## **COMMISSION OF ARCHITECTURAL REVIEW REGULAR MEETING AGENDA**

**September 25, 2025**

DATE: September 25, 2025  
TO: Commission of Architectural Review  
FROM: Renee Burton, Division Director of Planning  
RE: Certificate of Appropriateness application PZ25-00467 filed by Keisha and Duane Harper to add an addition to the principle structure at 864 Pine Street (Parcel 22005).

Exterior Elevation Right

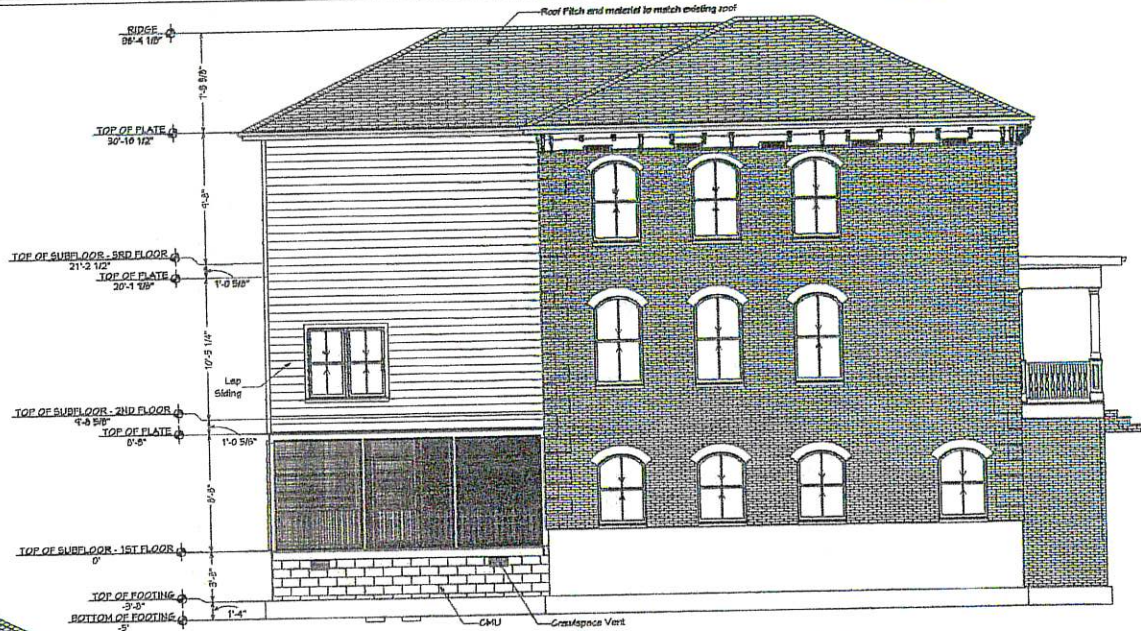
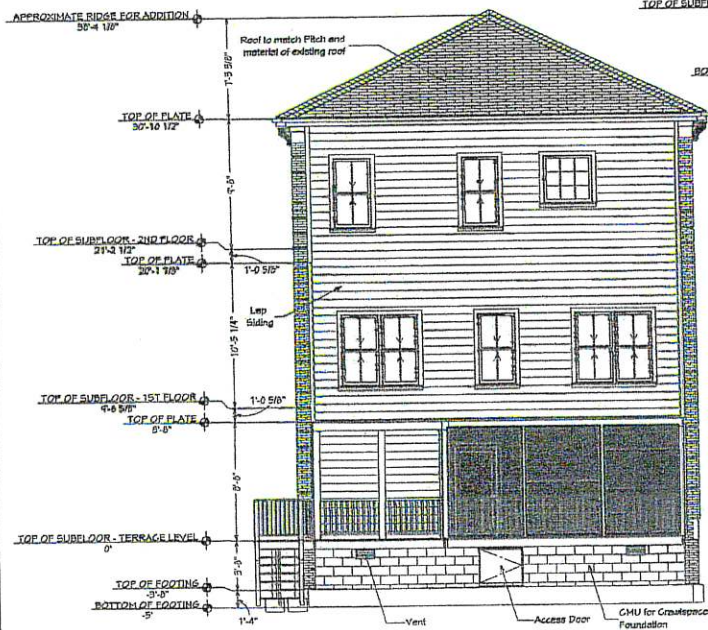
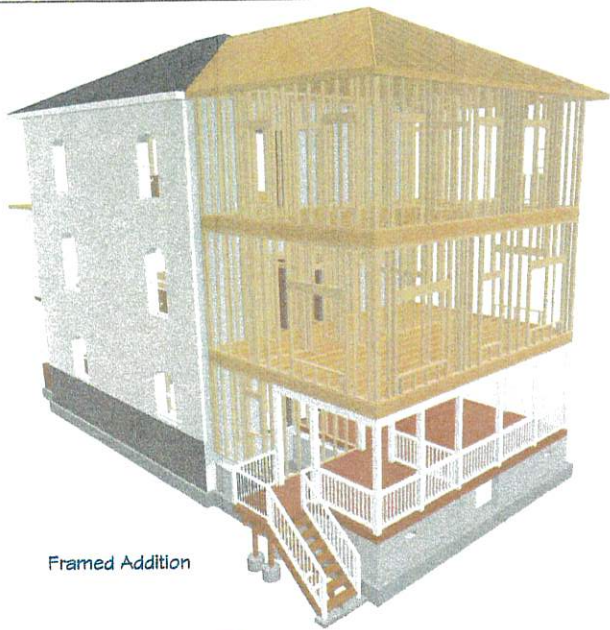
While the proposed Hardie Plank siding differs from the original brick, wood plank was traditionally used on Italianate houses, making the material choice consistent with historic precedent, though not identical to the original. However, the proposed addition features square windows, which do not match the existing arched windows, potentially reducing the visual cohesion of the façade. Therefore, staff recommends approval of PZ25-00467 with the condition that the new windows be revised to feature arched tops to match the existing openings.
